BRT: Support Bracket Addition between Wiper Motor

Mounting and Idler Bracket

Property name and Top bus number: 42 and 60BRT buses

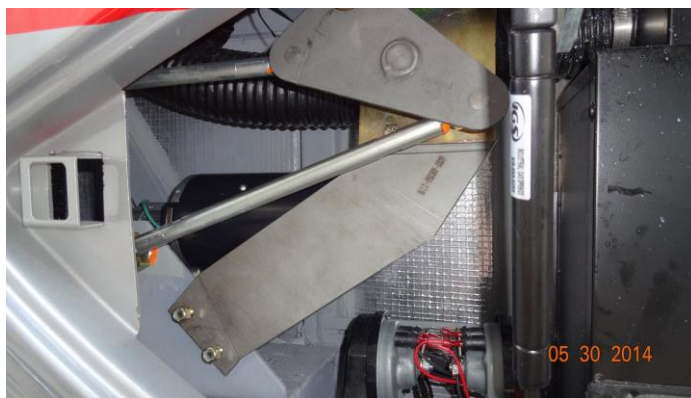
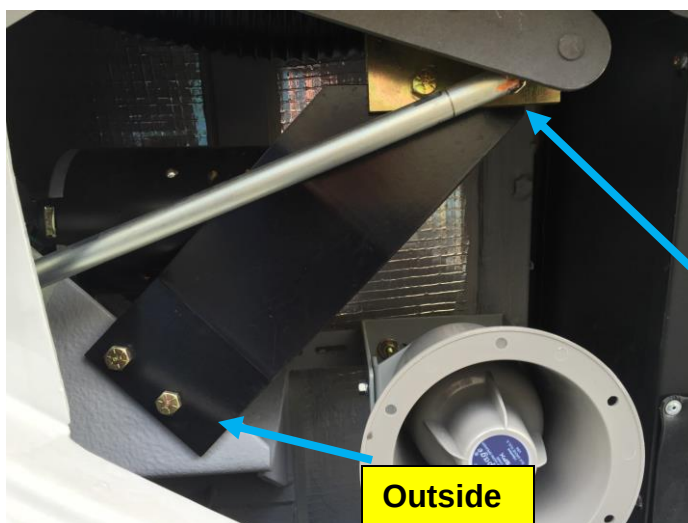
4. Line up support bracket PN 611-2639-003 to mark pilot holes. Drill holes with a 3/16 drill bit to start with, then use a 5/16 drill bit for the final holes. Mount support bracket using 5/16 hardware as listed above. Ensure that the bottom of the support bracket is mounted outside of the wiper mount and the top of the bracket mounted inside the intermediate bracket as photos shown below.
